RENESAS TECHNICAL UPDATE

Product Category	MPU&MCU		Document No.	TN-SH7-A607A/E	Rev.	1.00
Title	The error correction and change description about bit synchronous circuit of I ² C bus interface 3 (IIC3)		Information Category	Technical Notification		
Applicable Product	SH7200 Series SH7210 Series SH7260 Series	Lot No.	Reference Document	See below		
		ALL

1. Error correction about time for monitoring SCL

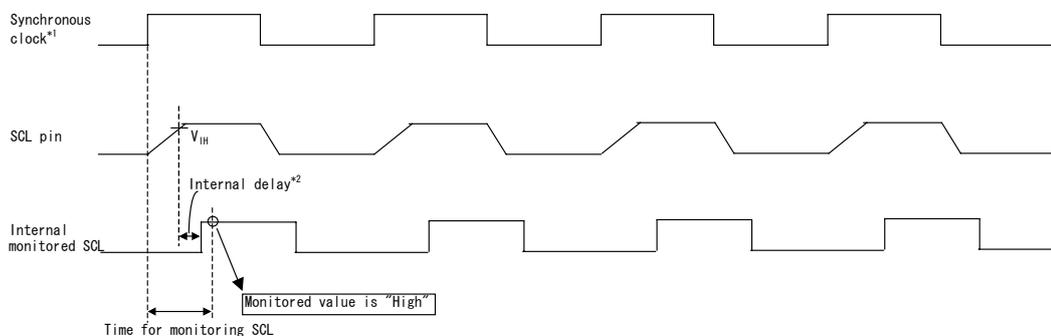
Following shows error correction of values on CKS[3]=1.

CKS[3]	CKS[2]	Time for Monitoring SCL
0	0	9 tpcyc
	1	21 tpcyc
1	0	19 tpcyc
	1	43 tpcyc

CKS[3]	CKS[2]	Time for Monitoring SCL
0	0	9 tpcyc
	1	21 tpcyc
1	0	33 tpcyc
	1	81 tpcyc

2. Change description about bit synchronous circuit timing figure

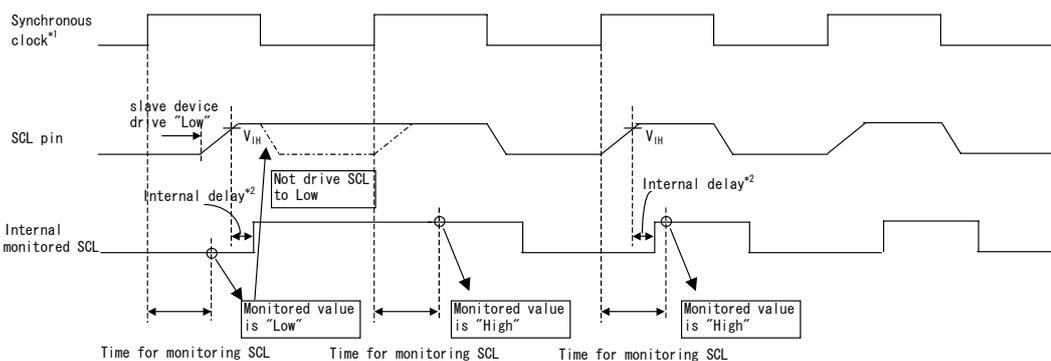
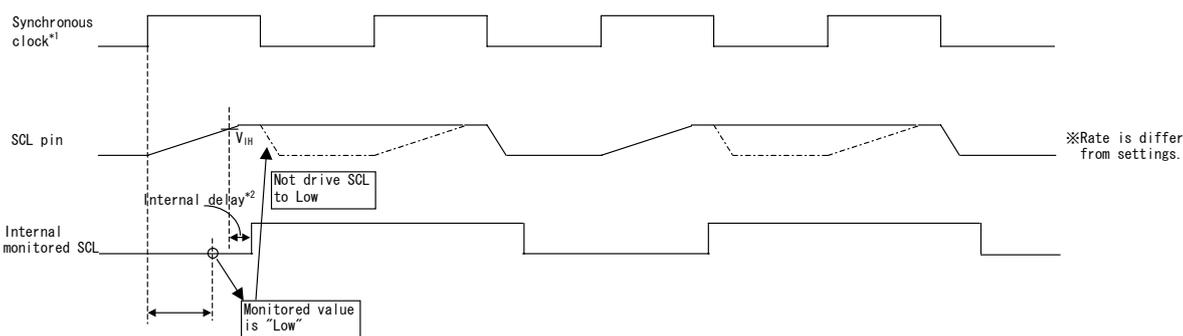
Following shows the figure of bit synchronous circuit timing after description changed.

- Add "Normal case" and "Case that SCL is driven to low by the slave device".
- Add supplemental description.

- Notes:
- *1 Clock whose rate is set by CKS[3:0] bits of I²C bus control register 1 (ICCR1).
 - *2 3~4 t_{pvc} when NF2CYC bit of NF2CYC register (NF2CYC) is 0, and 4~5 t_{pvc} when NF2CYC bit is 1.
